"ESF / GROA Interface Drawing Update - FY1995"

B00000000-01717-0200-00124, Rev 00C

Design Analysis Review Summary

Design Analysis Cover Sheet

FIGURE 7-5

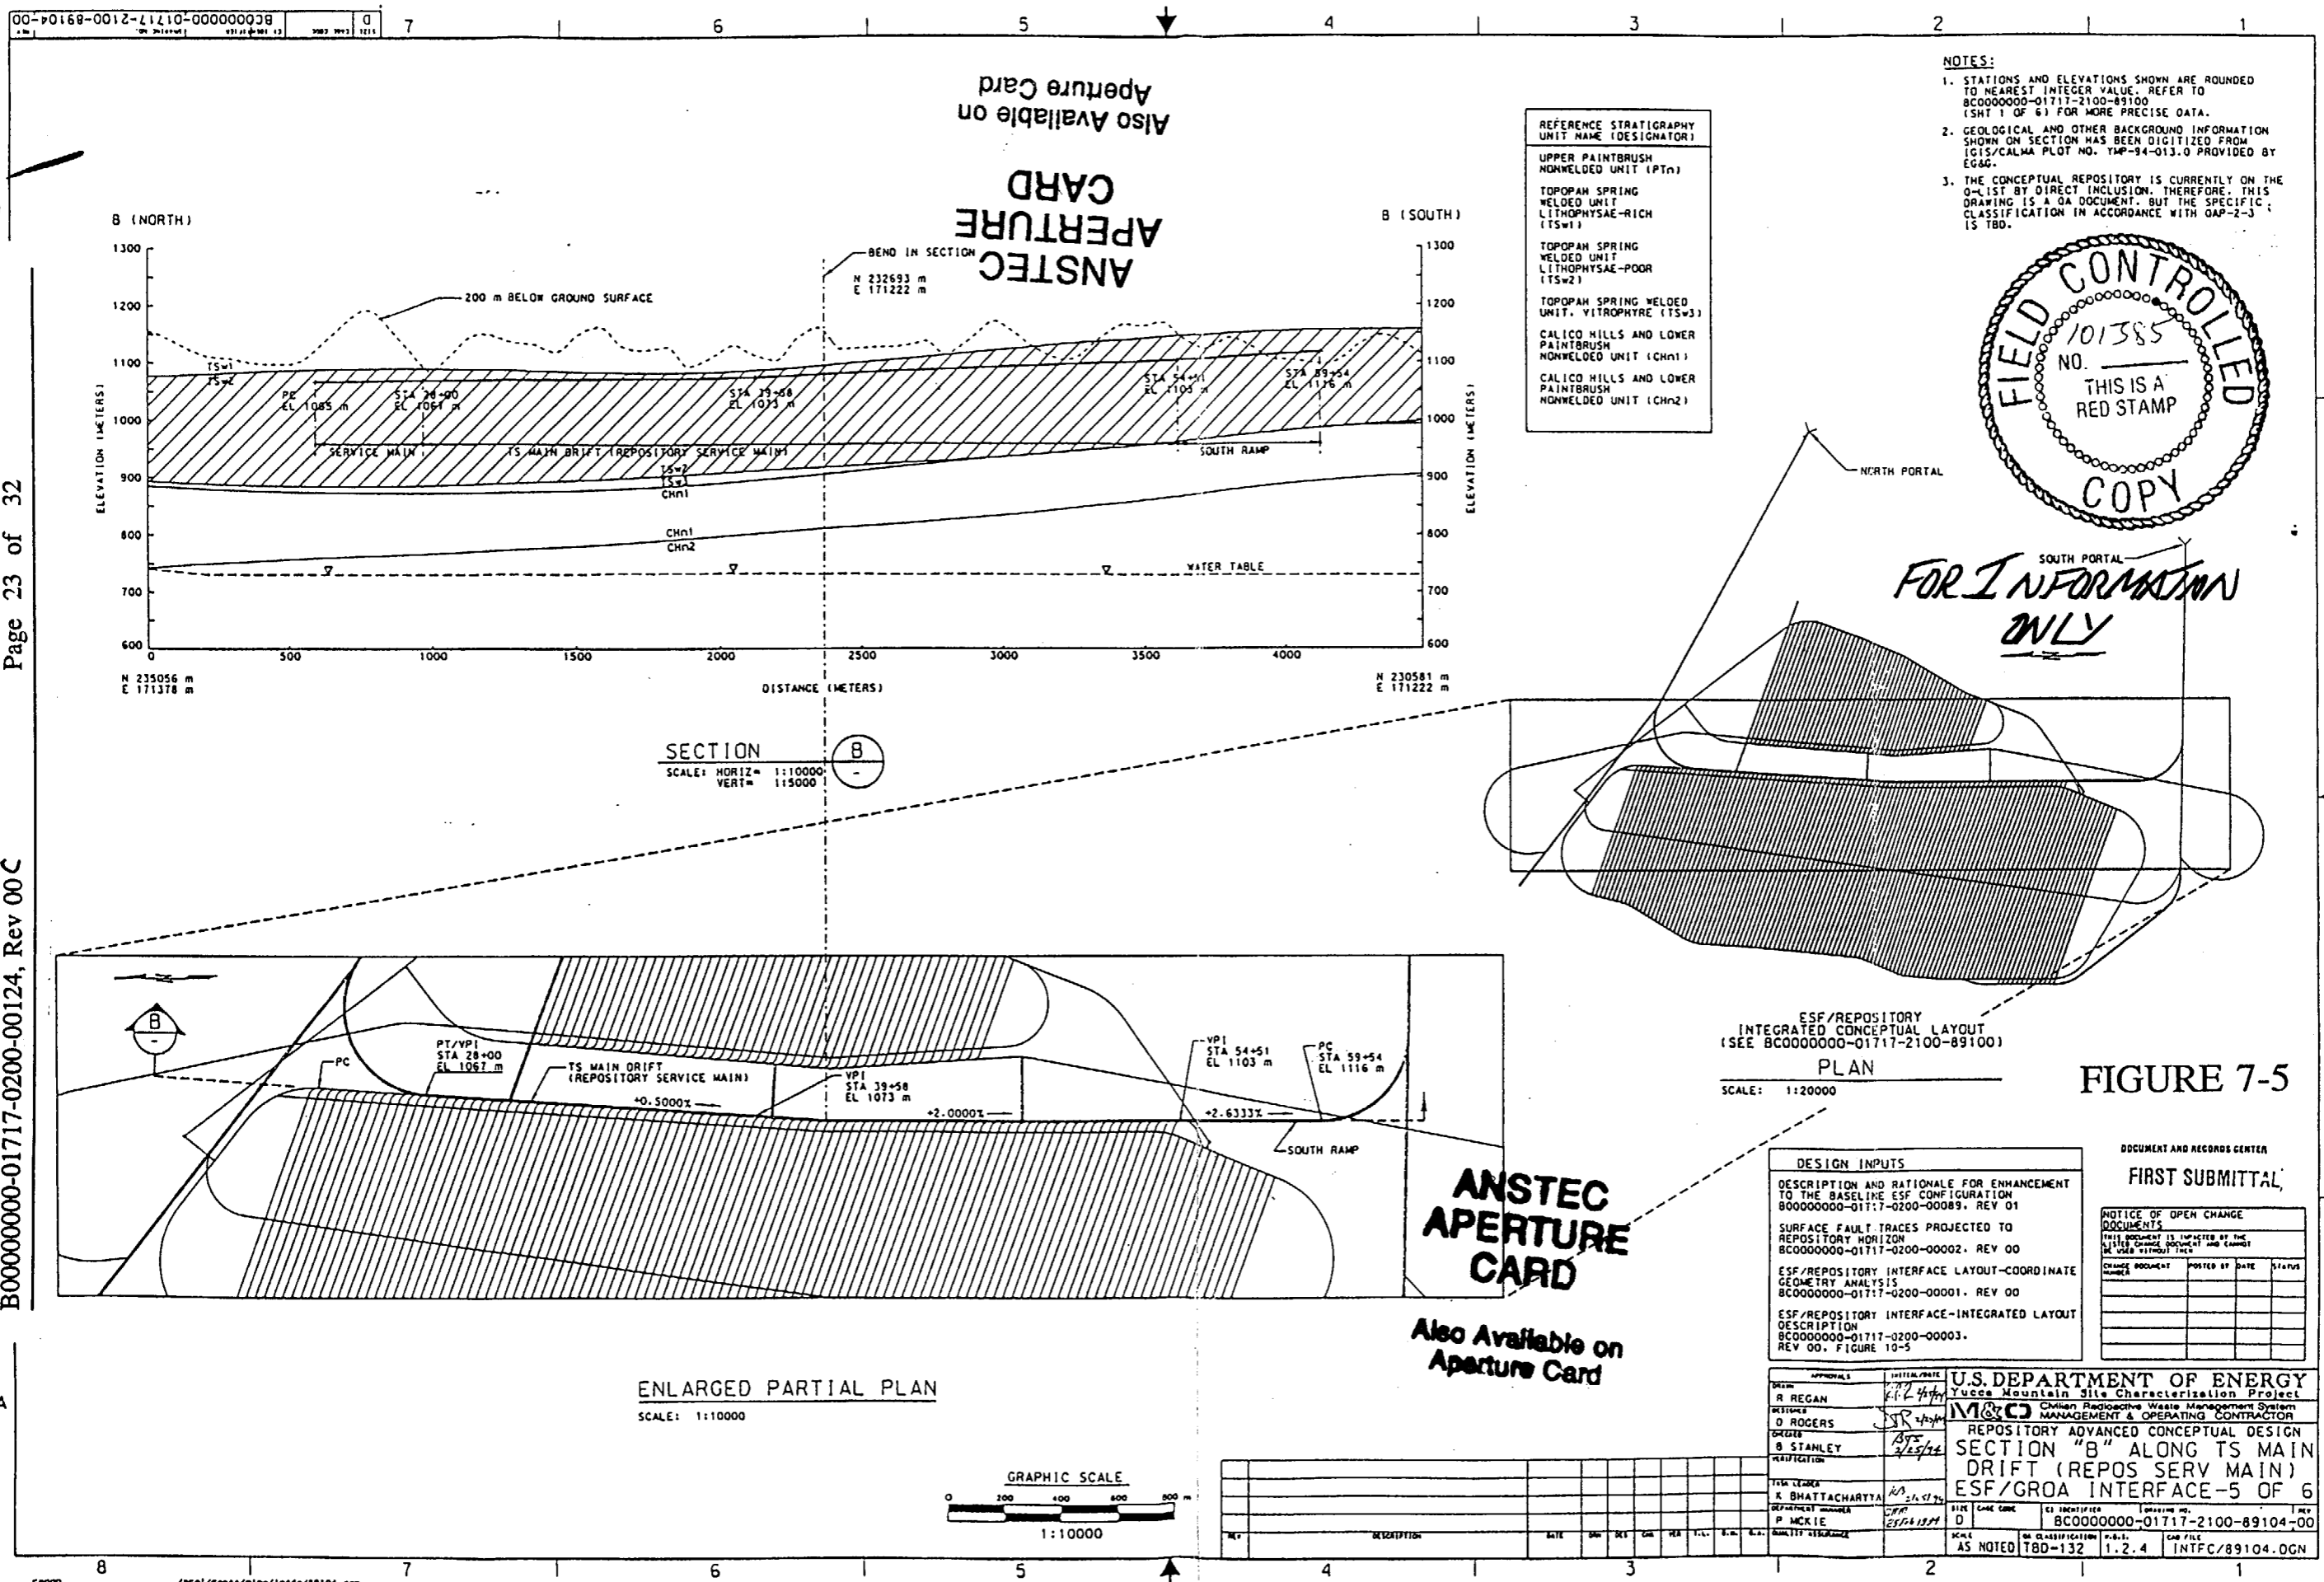
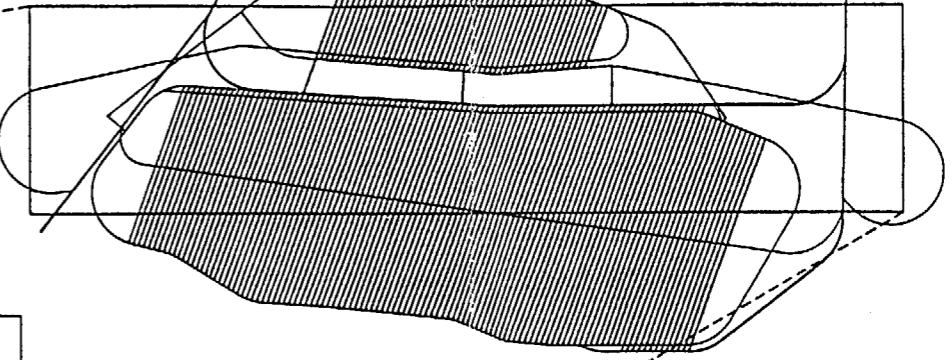
The vertical alignment of the ESF main drift started at approximately Station 28+00, elevation approximately +1067 meters with a grade of +0.5%. It continued at this grade to about Station 39+58 where the grade transitioned to +2.0%. This grade continued to the bottom of the South Ramp, at about Station 54+51, where the grade increased to +2.63%. This grade was then maintained throughout the south ramp to its intersection with the surface. The straight segments were connected by short vertical curves. This can be seen on Figures 7-1 and 7-5.

approximately +1065 meters and at approximately Station 28+04, at a grade of +1.35%. The grade remains unchanged throughout the main drift. The grade changes at the bottom of the south ramp, at about Station 56+54, to +2.57%. See Figures 7-7 and 7-12.

FIGURE 7-6

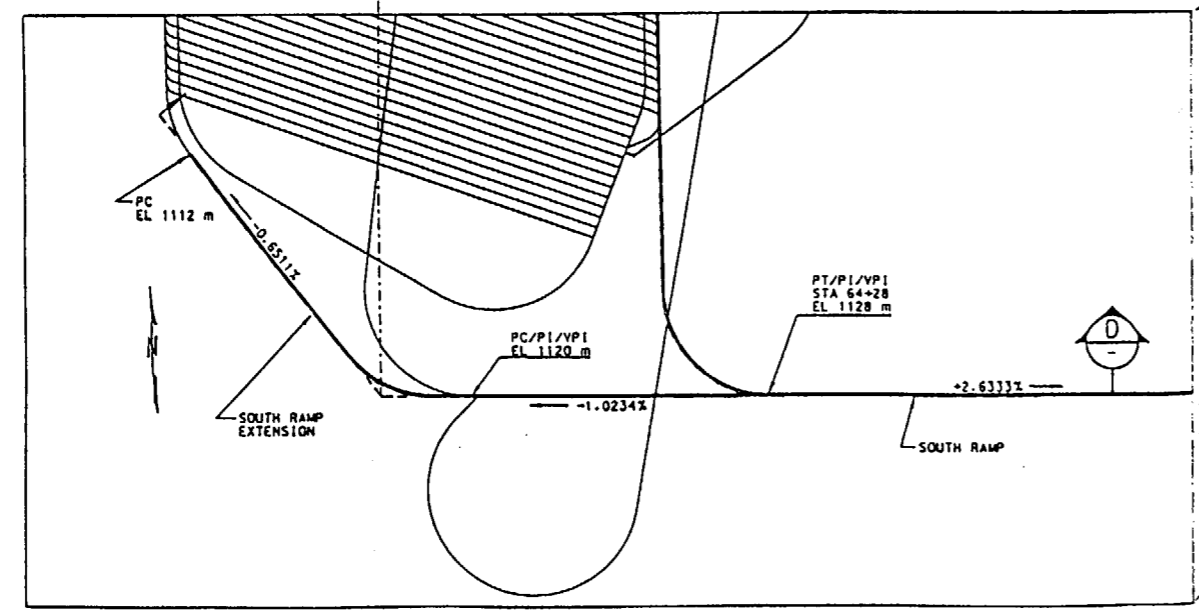
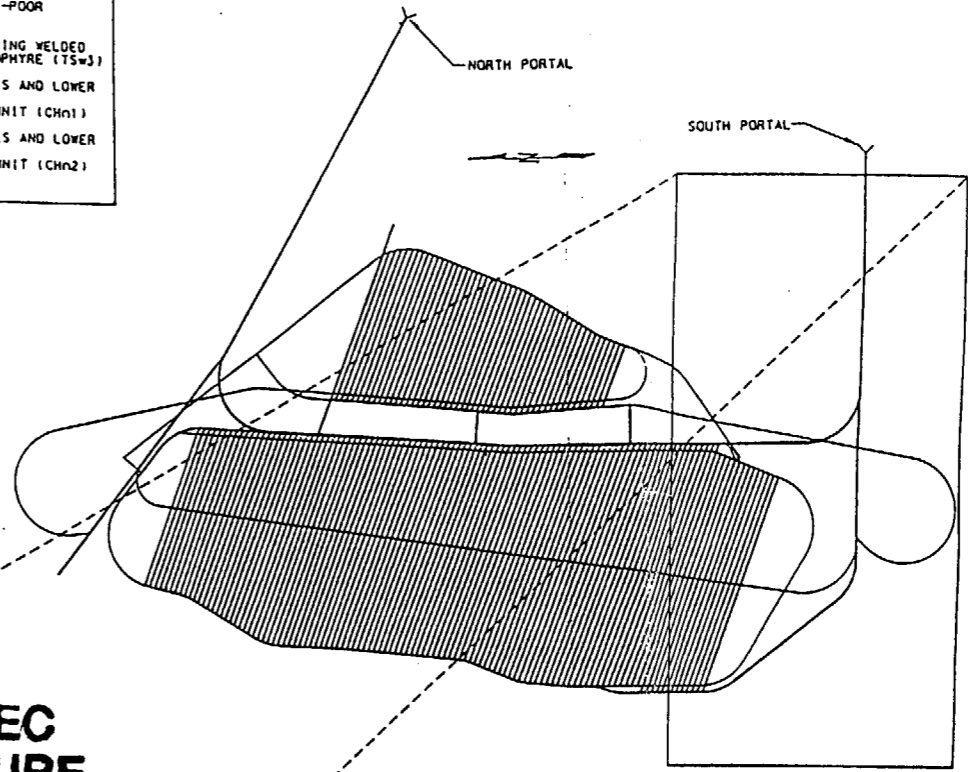
The ESF as shown on the original interface drawings contained a "South Ramp Extension" (SRE), an "Imbricate Fault Drift," and an area designated as a "Main Test Area," or MTA. These are shown on Figures 7-1 and 7-2, and a cross-section partially along the Imbricate Fault Drift is shown in Figure 7-3. A cross-section partially along the South Ramp Extension is shown in Figure 7-6.

The South Ramp Extension, Imbricate Fault Drift, and Main Test Area (MTA) have been dropped from the ESF configuration.

FIGURE 7-7

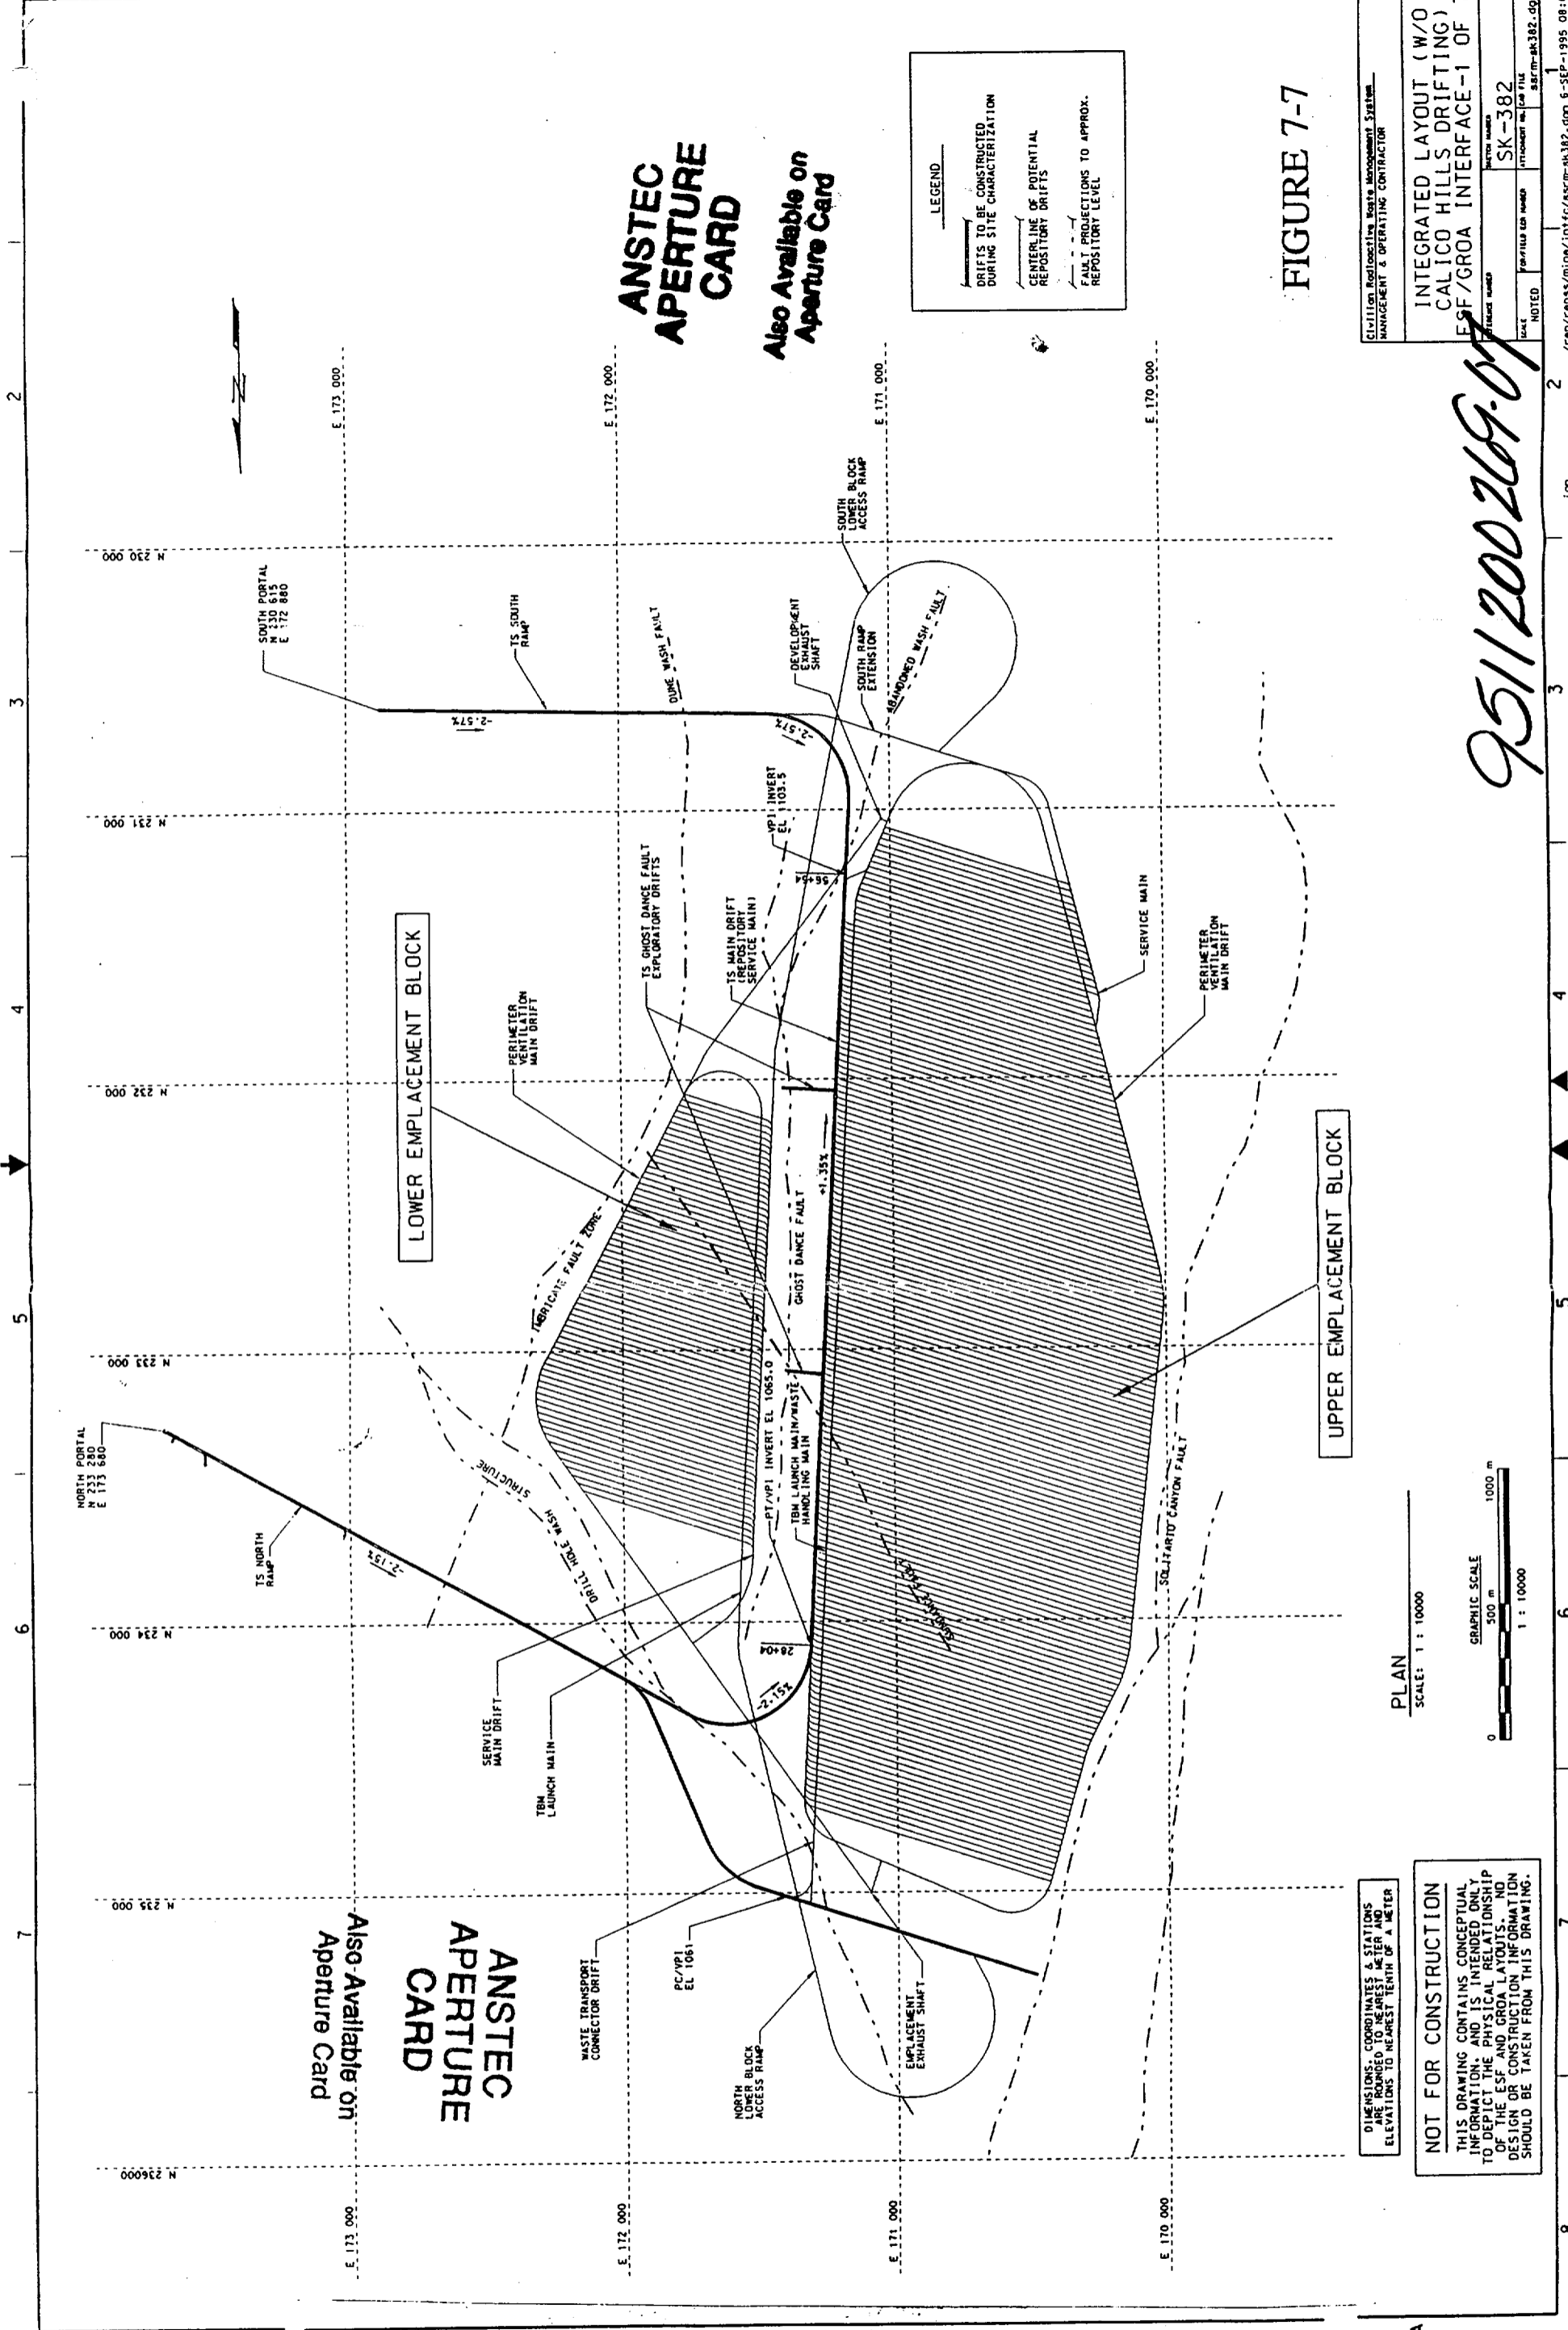
Proposed Change

Figures 7-1 and 7-2 show a drift, running roughly north-south, which bisects the upper block and called out as the "Potential Waste Main" on the figures. Figure 7-7 does not show this drift. This drift, if employed, would be used as an additional access to the emplacement drifts. It would, in effect, cut the length of the drifts in half. This could be an advantage if, for example, backfilling of emplacement drifts were to be required at decommissioning.

Proposed Change

The proposed revision to the ESF/GROA interface drawings shows a straight ESF main drift from the bottom of the north ramp at approximately Station 28+04 to the bottom of the south ramp at approximately Station 56+54. See Figures 7-7 and 7-8.

The shape of the upper emplacement block has changed primarily in two areas, the north end and the southwest area. Multiple adjustments have been made which have resulted in the shape shown on Figures 7-7 and 7-8. The adjustments are related, as discussed below. The current baseline drawing shows, in the southwest area of the upper block, that the southernmost 30-35 emplacement drifts extend to the west to an Easting of approximately 169,800 meters. In the update, the western ends of the southernmost emplacement drifts extend only to an Easting of between 170,000 and about 170,300: i.e., they will be 200-400 meters shorter than they are shown in the current baseline drawings.
